STAFF REPORT AND RECOMMENDATION TO THE DESIGN COMMISSION

CASE FILE: LU 16-100496 DZM MS
PC # 14-242574
Block 290
REVIEW BY: Design Commission
WHEN: May 19, 2016 @ 1:30pm
WHERE: 1900 SW Fourth Ave., Room 2500A
Portland, OR 97201

Type III Design Review and Master Plan Amendments to the Con-way Master Plan for a new multi-story residential building with ground floor retail, below-grade parking, and roof terraces. Proposed exterior materials include: brick in varying shades, metal panel, high-density fiber cement plank, butt-glazed storefront, aluminum and wood sliding storefronts, metal canopies, vinyl windows and doors, and glass balconies. The proposal also includes development of the NW Quimby festival street.

EAST ELEVATION

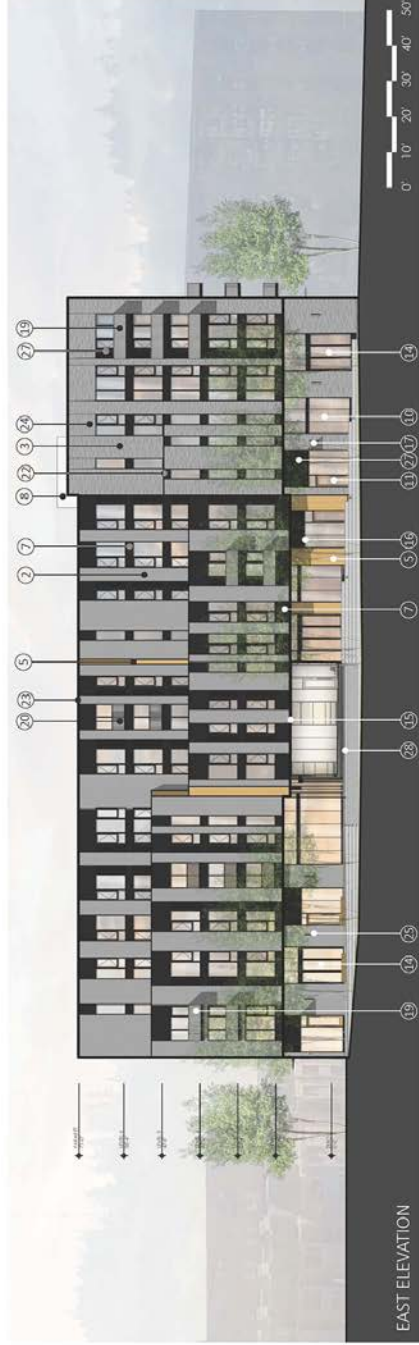
Besides detailing concerns, staff notes that the varied panels and shifting planes, while potentially interesting, feels rather chaotic both in the elevations and renderings, and particularly as a backdrop for the future park as well as the public square. Staff imagines that visitors to the park will go to the park with a desire to feel a sense of calm; however, the proposed east façade has the potential to disrupt that feeling. Therefore, staff suggests that this façade, in particular, should be significantly simplified so that the future park may provide opportunities for serenity within the neighborhood. In contrast, the interior façades of the square must balance a sense of calm and that of activity to support the desired activities in the square.

shifting vertical panels within the same plane. Generally, staff believes that the proposal stresses diversity in volume and form at the expense of coherency. As is noted under D8 above, staff suggests that the façades be simplified, particularly at the east, facing the park.

This guideline is not yet met; however, with additional consideration of the planar and volumetric articulation of the building, composition of the façades (particularly the east façade facing the park), this guideline may be met.
